Commonwealth Edison Company  
Byron/Braidwood Units 1 and 2  
Relaxation of MSSV Setpoint Tolerance to +/-3% - Revised SECL

Enclosed please find Revision 1 to safety evaluation SECL 90-469, previously transmitted via Reference 1. The revised safety evaluation clarifies the section of the ASME code associated with the main steam safety valves.

WESTINGHOUSE NUCLEAR SAFETY  
SAFETY EVALUATION CHECK LIST

APPENDIX B  
UFSAR MARKUPS

FIGURE 15.2-5

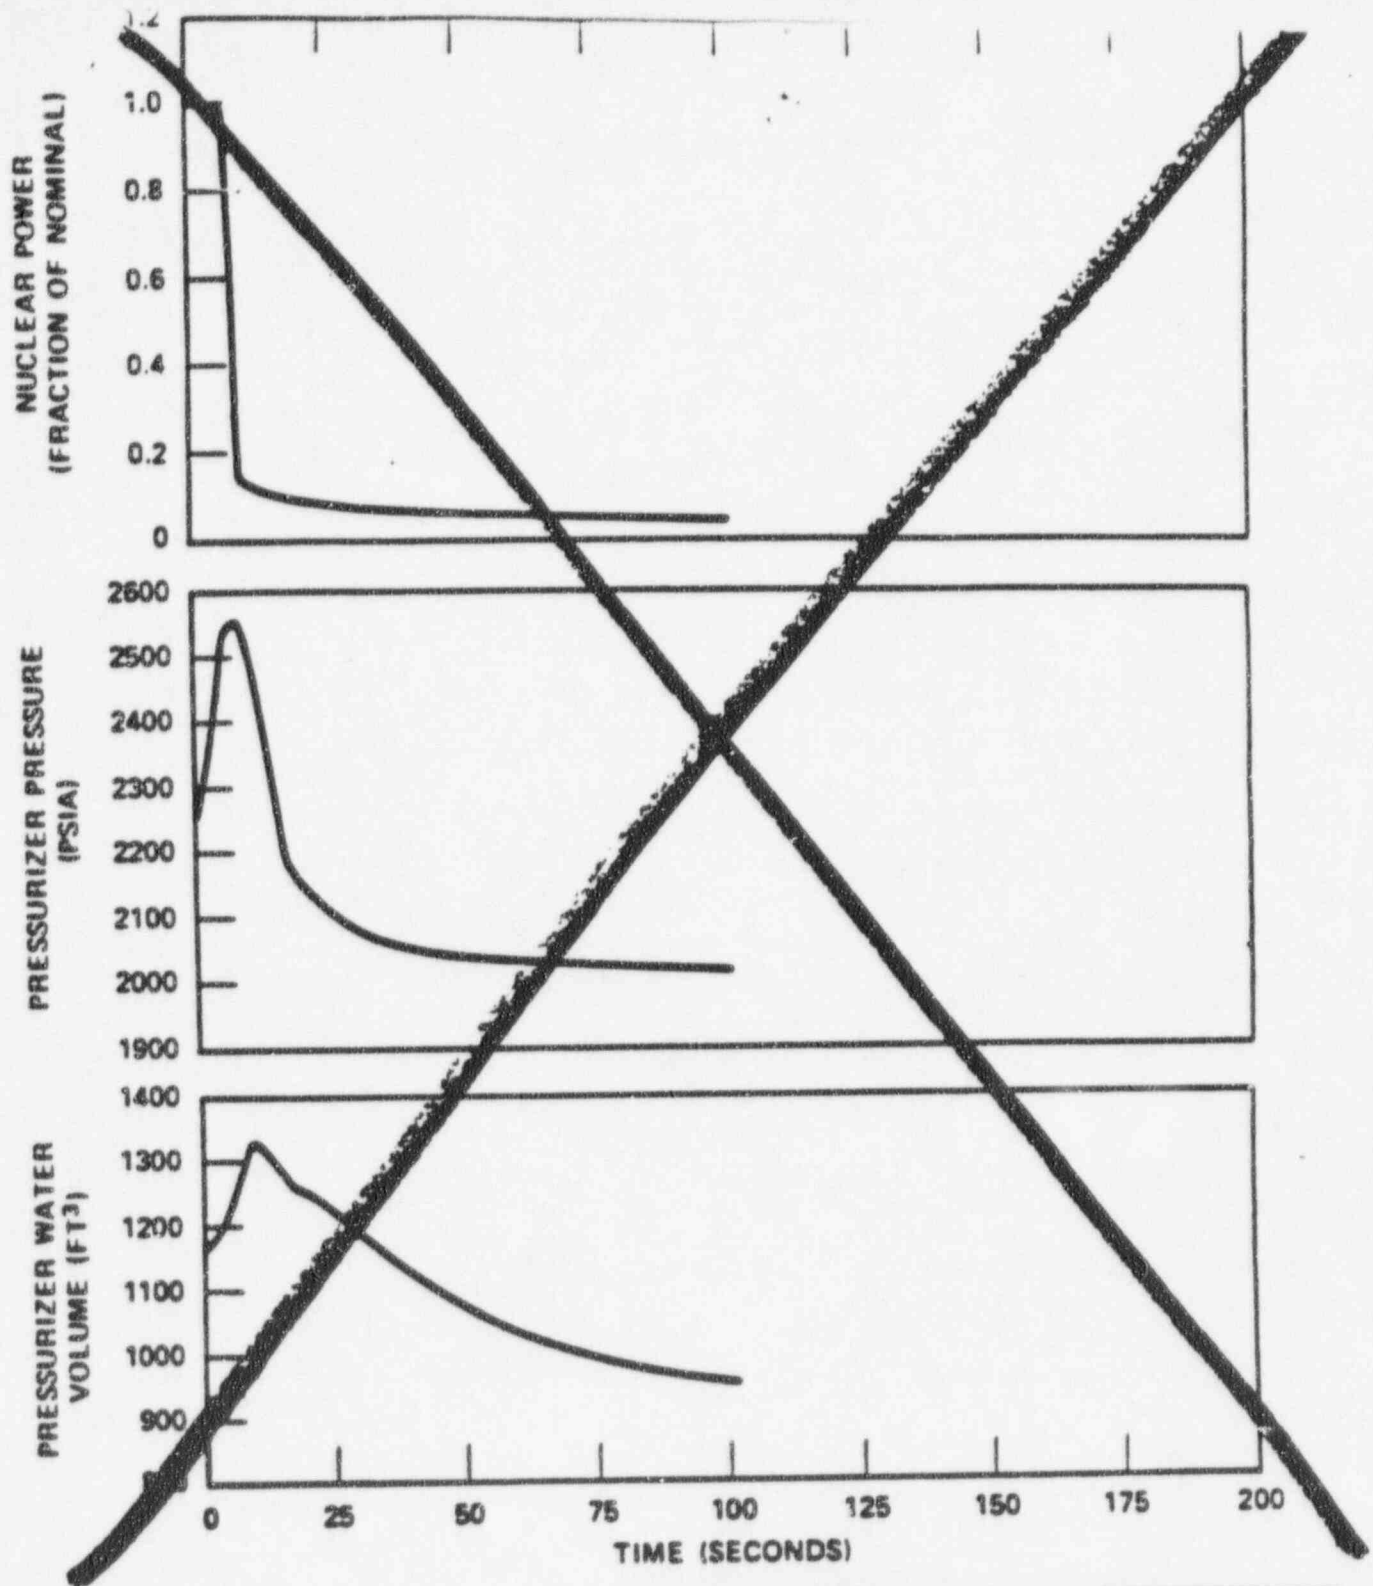
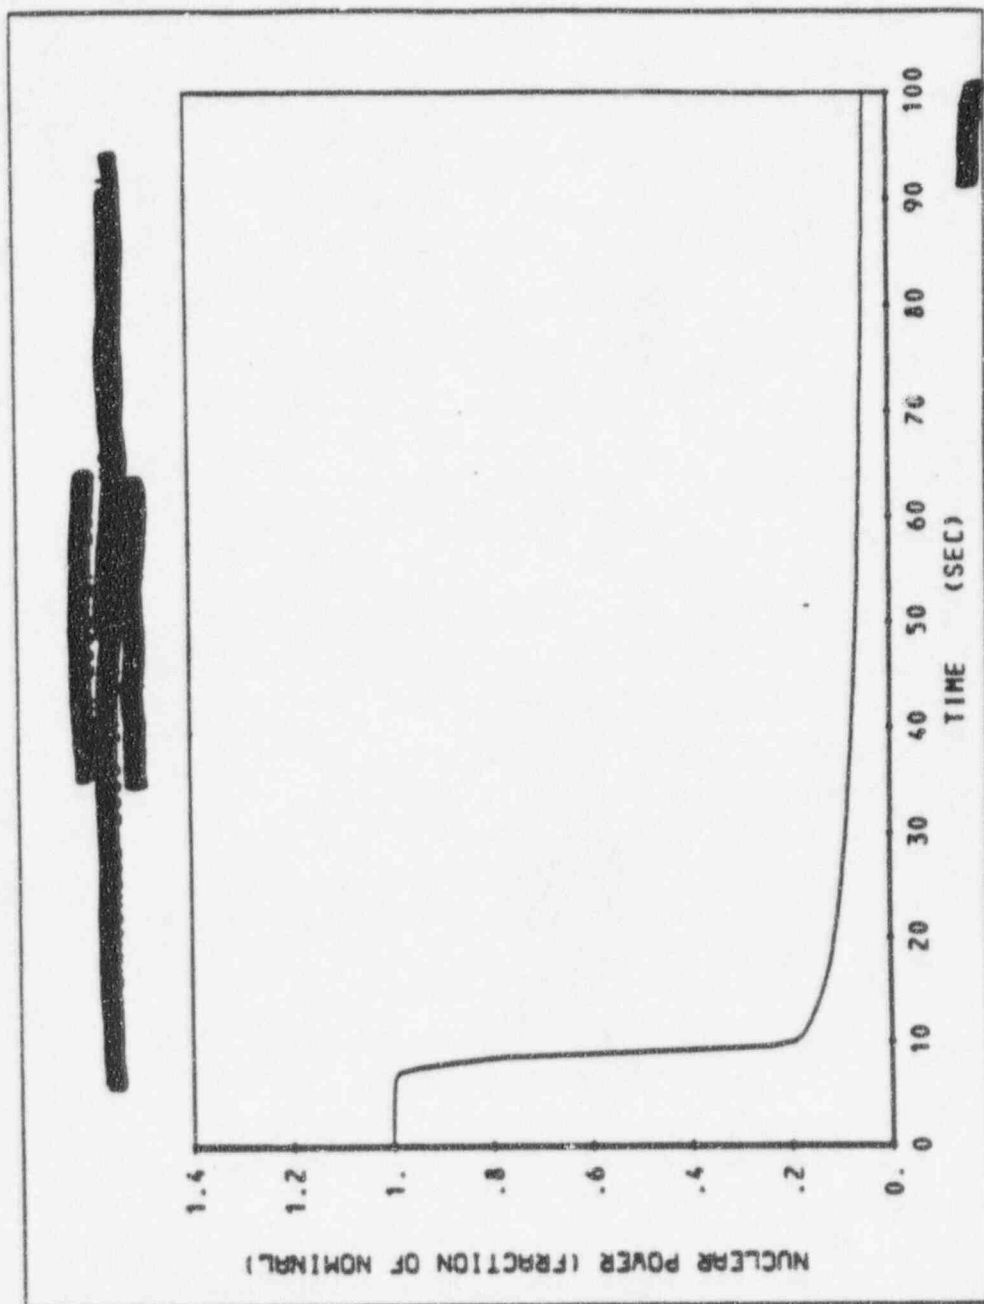
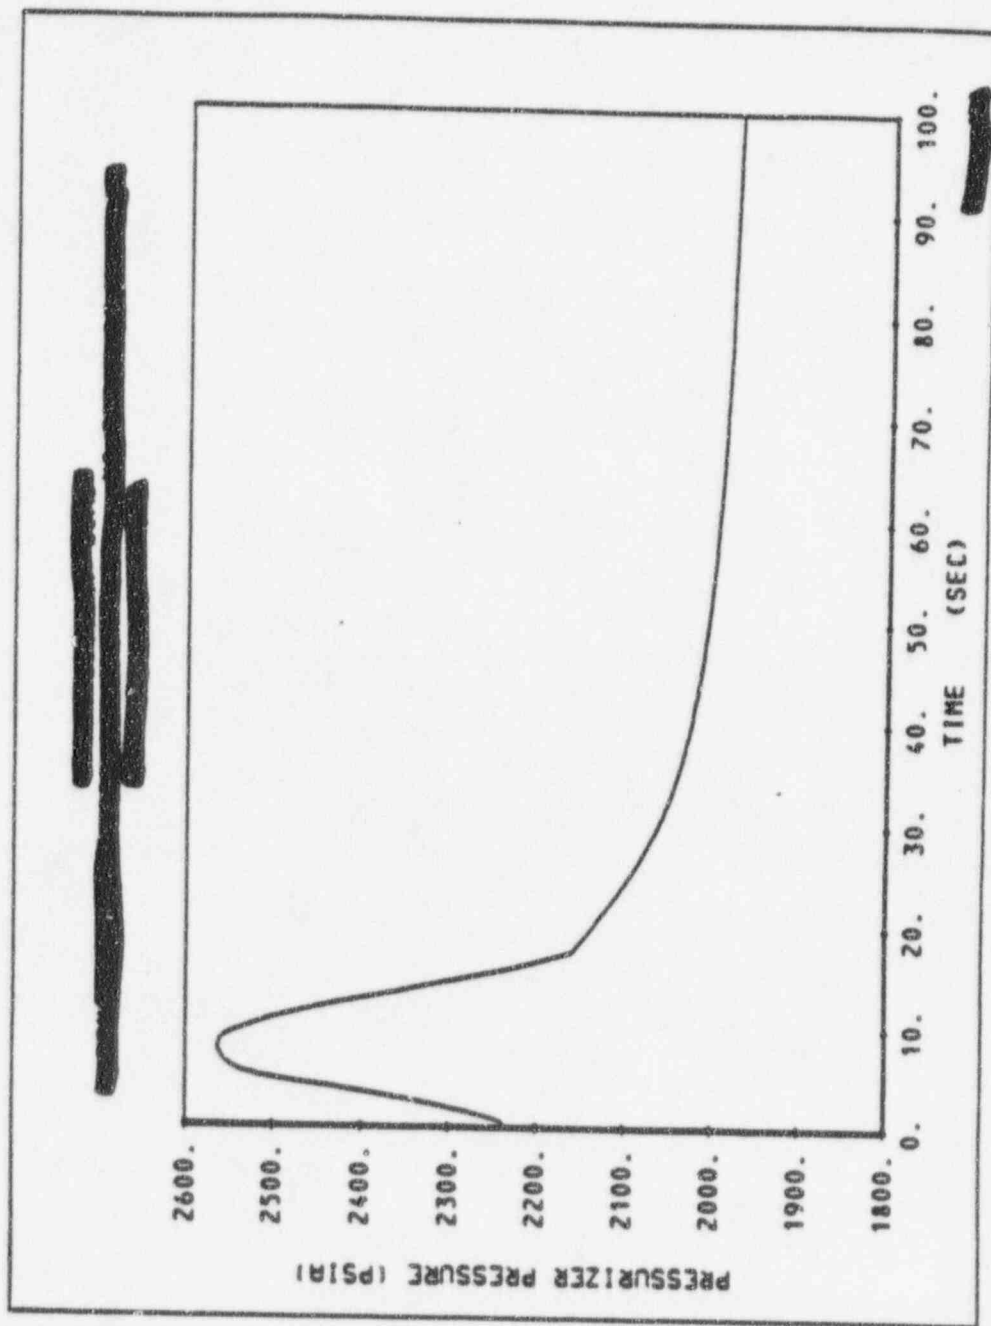
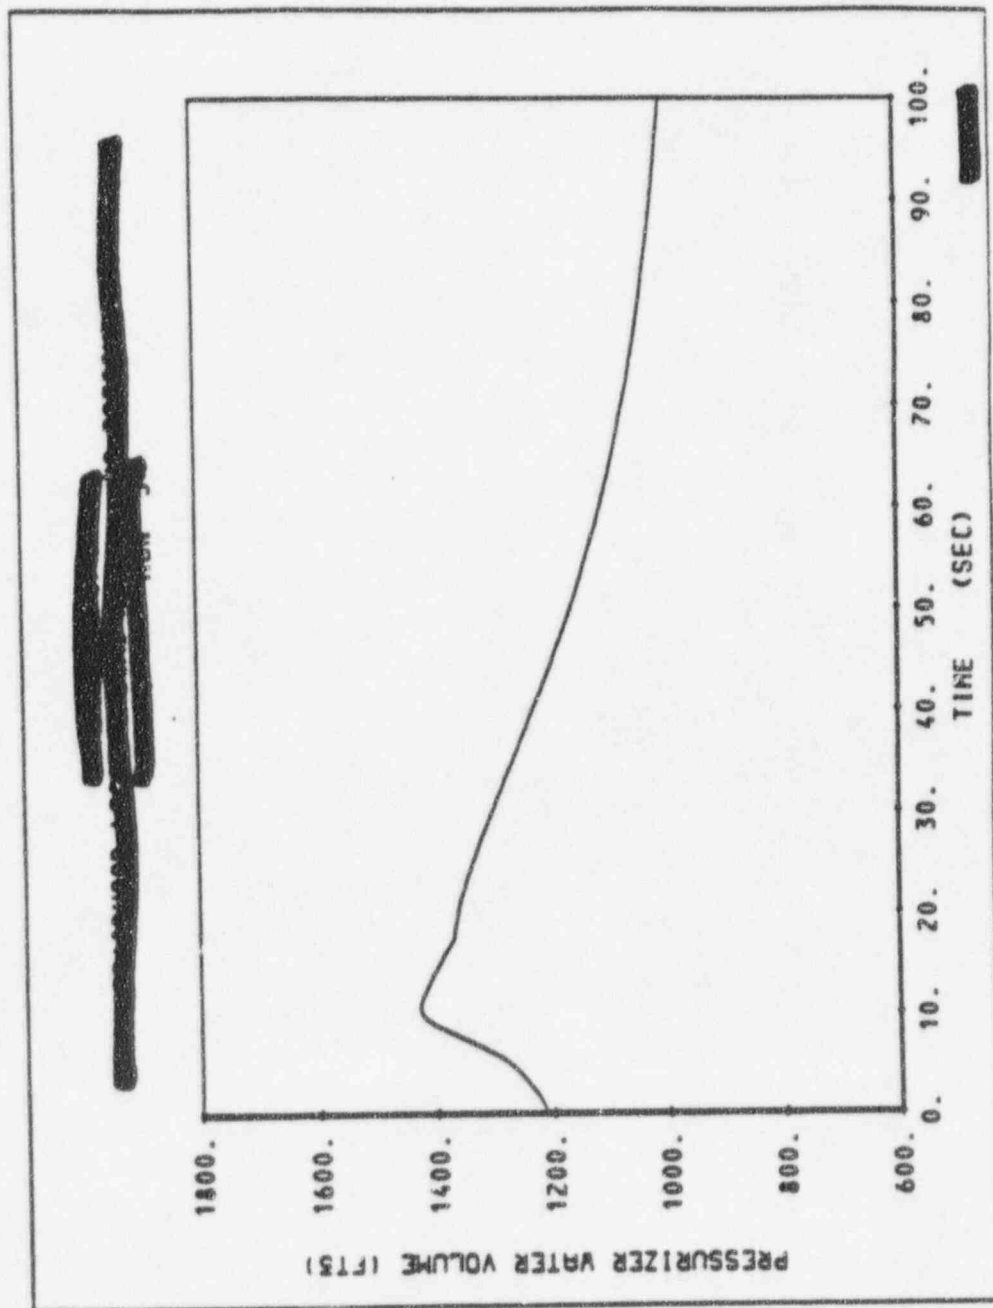
The turbine trip accident was also studied assuming the plant to be initially operating at full power with no credit taken for the pressurizer spray, pressurizer power-operated relief valves, or steam dump. The reactor is tripped on the high pressurizer pressure signal. Figures 15.2-5 and 15.2-6 show the transients with a least negative moderator coefficient (minimum reactivity feedback). The neutron flux remains essentially constant at full power until the reactor is tripped. The DNBR ~~increases~~ ~~throughout the transient and never drops below its initial value.~~ In this case the pressurizer safety valves are actuated, and maintain system pressure below 110% of the design value.

REPLACE WITH  
the following  
Figures
